DOCKET NUMBER 50-483 CALLAWAY PLANT UNION ELECTRIC COMPANY PROPOSED REVISION TO TECHNICAL SPECIFICATIONS TO CORRECT EDITORIAL ERRORS

DESCRIPTION OF PROPOSED CHANGES; SIGNIFICANT HAZARDS EVALUATION; AND ENVIRONMENTAL EVALUATION

MARKED-UP PROPOSED IMPROVED TECHNICAL SPECIFICATIONS

3.7.16 Fuel Storage Pool Boron Concentration

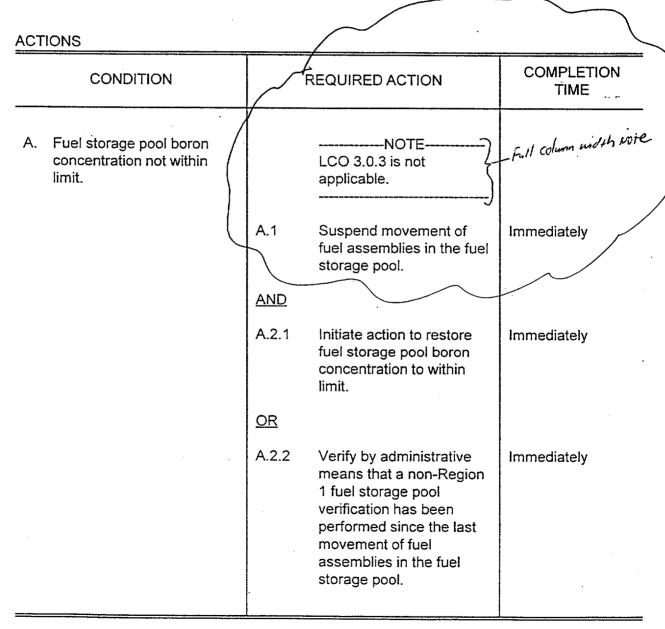
- 5. Pages 3.7-36. Under 3.7.6 ACTION, CONDITION A, the NOTE provided should be a full column width note. The placement provided in the certified copy is incorrect due to typographical error.
